Reference: 21115_DRUMMOYNE RESERVOIR_STRUC INTEGRITY

RE: DRUMMOYNE RESERVOIR - MAINTAINING STRUCTURAL INTEGRITY**Attention: Steve Milton**

Figure 1. Proposed new stair core and braced wall below existing tank

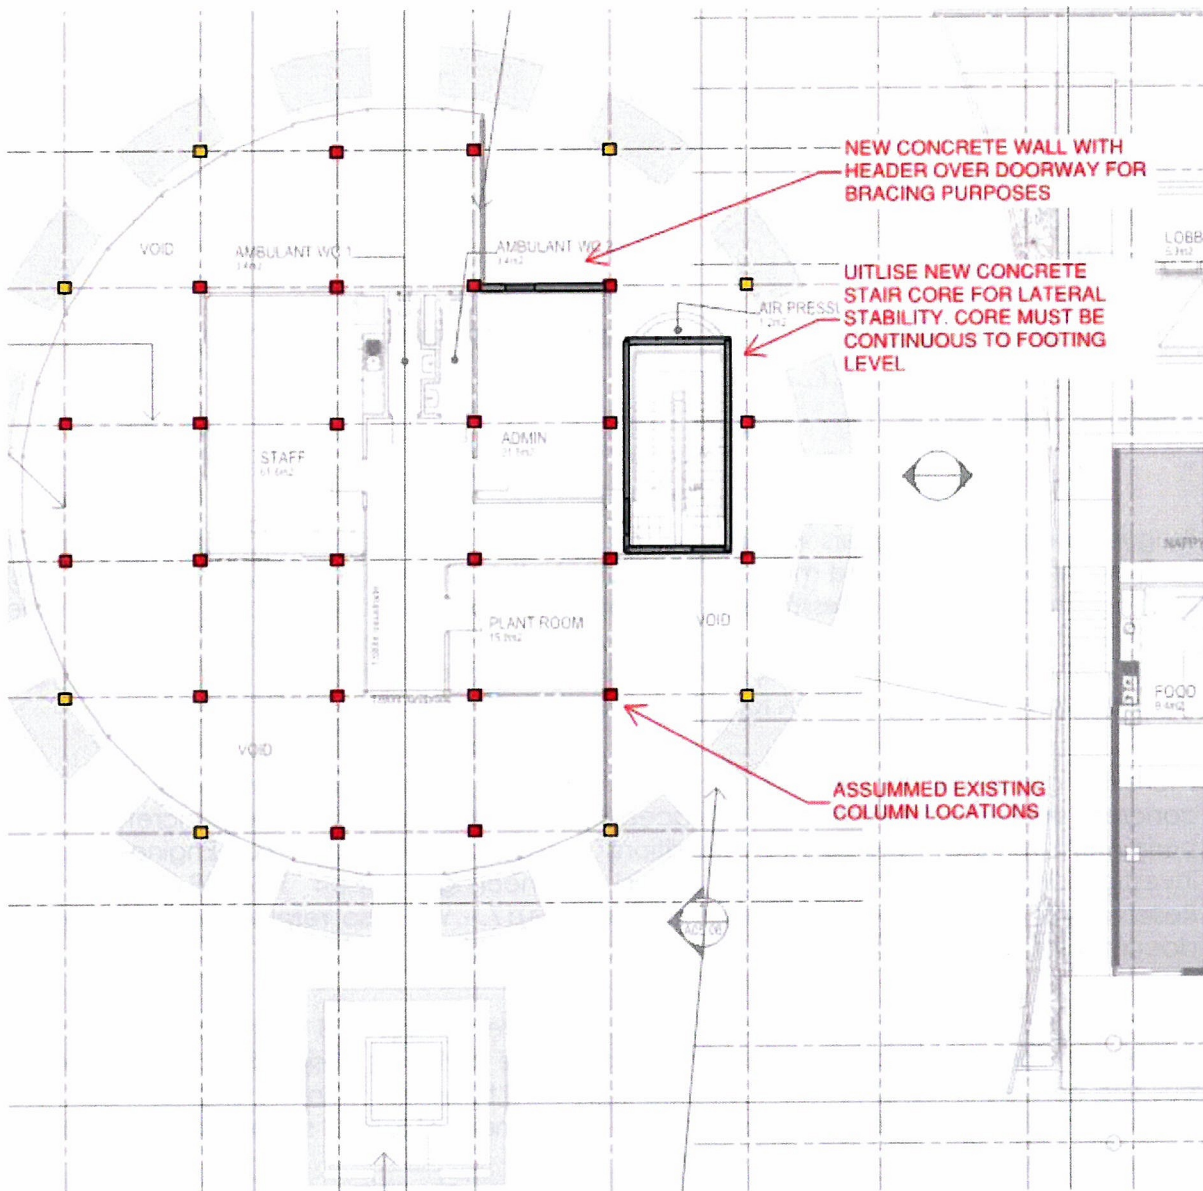
1. Provide temporary bracing to the existing structure in accordance with all Australian Standards and SafeWork NSW guidelines prior to any brace removals. Temporary bracing to remain until the final framing elements are installed in their final condition.
2. Inclusion of a new braced stair core and wall through the existing structure to foundation level. Refer part plan in Figure 1. Following.

Figure 2. Intermediate column restraint requirements

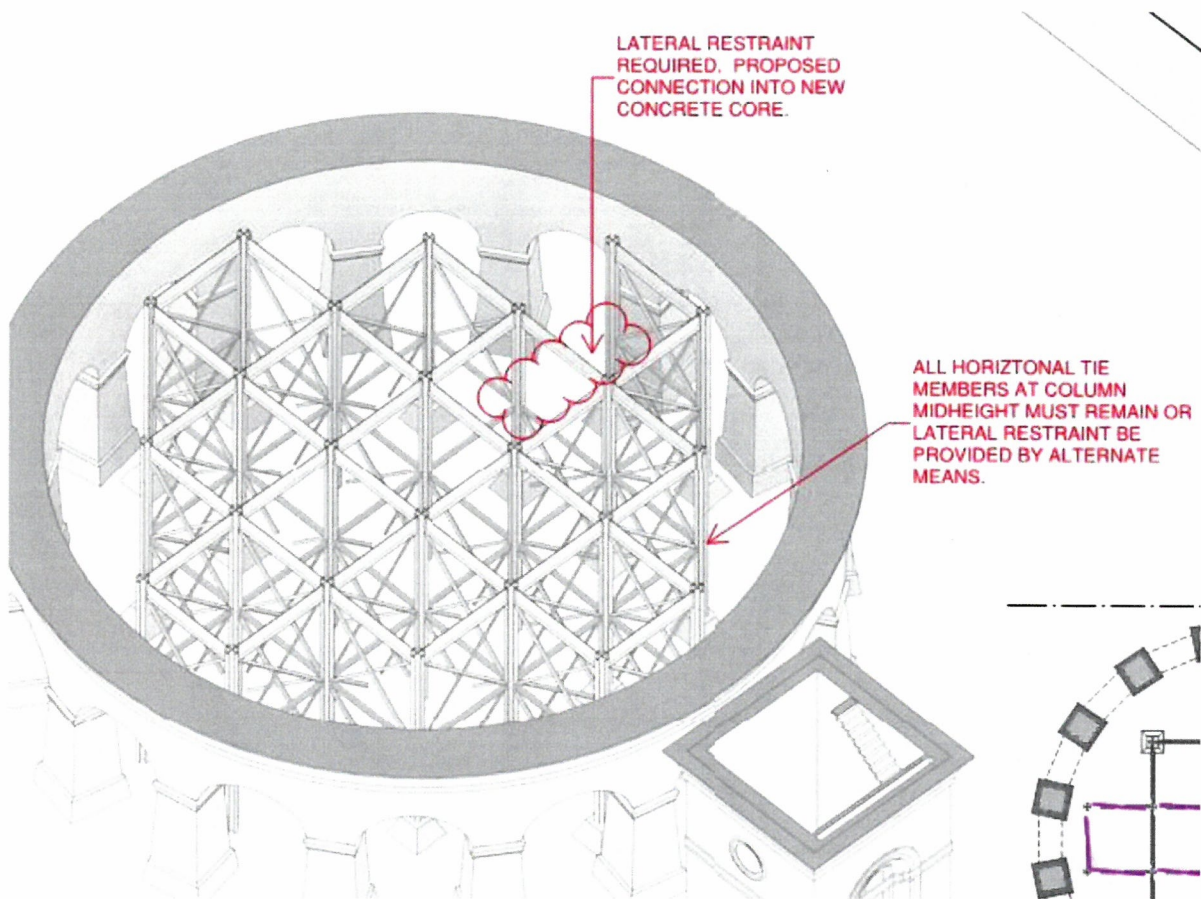
3. New stair core foundation with connection into adjacent existing foundations to resist proposed building lateral and vertical loads.
4. Maintaining lateral ties to all existing steel columns at intermediate level. Refer Figure 2. For notes on part plan.

Figure 3. Existing tank slab framing plan with proposed stair penetration shown indicatively

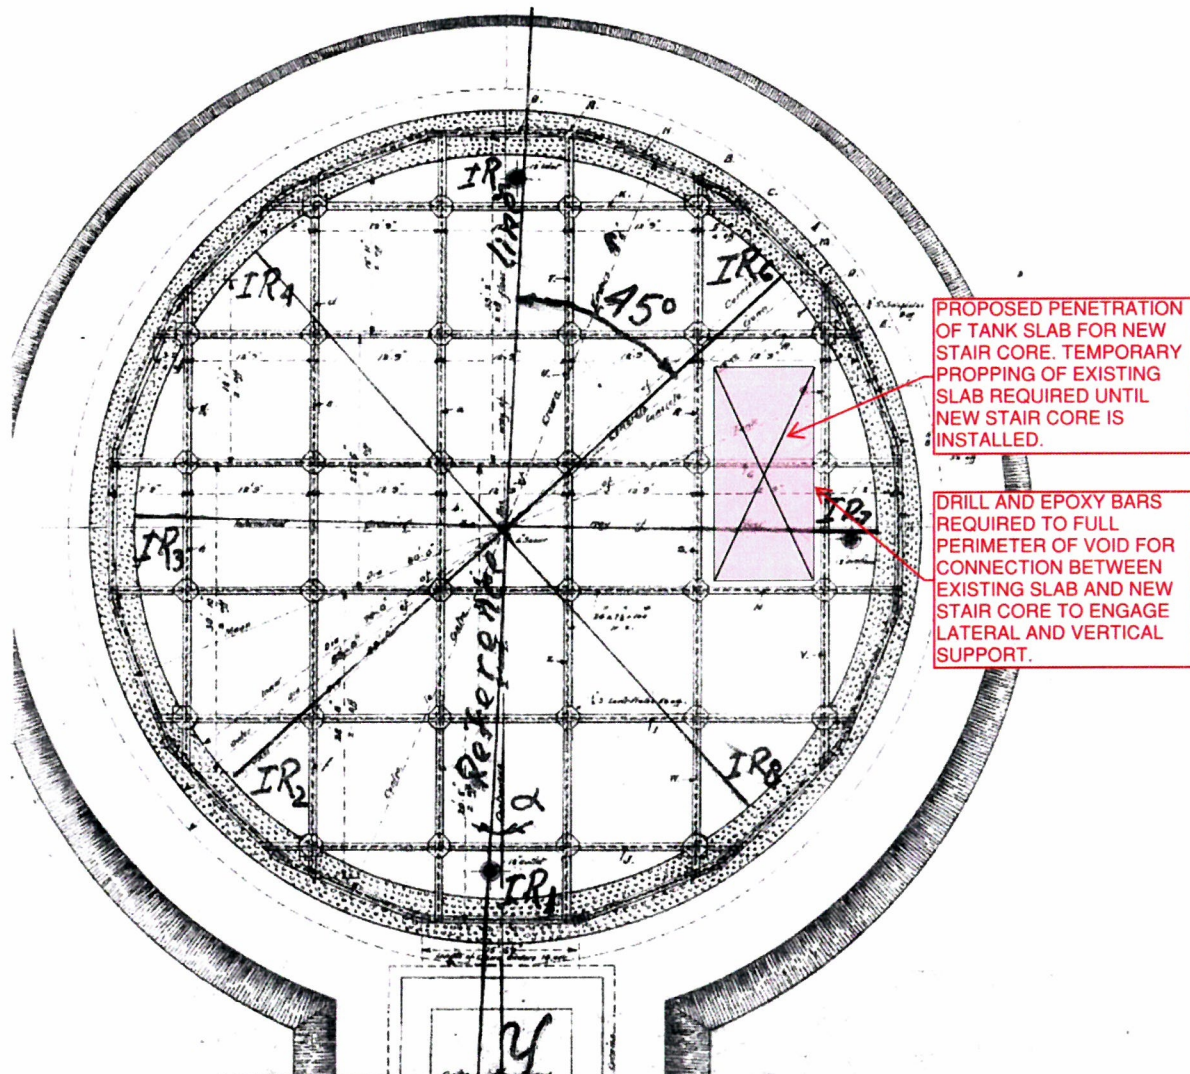
5. Where the new stair core is proposed, provide temporary propping prior to cutting existing slab. The penetration requires the removal of one slab support beam. The existing slab requires lateral and vertical support from the new stair structure, and this can be provided via drill and epoxy reinforcement connections to existing slab and reinforcement tied into the new concrete stair core, refer Figure 3.
6. Review of existing concrete feature arch façade and ensure tensile connections are provided between the concrete ring beam and vertical columns for earthquake loading ductility requirements.
7. The mezzanine structure between the ground level and tank base is assumed to be steel framed light weight construction.
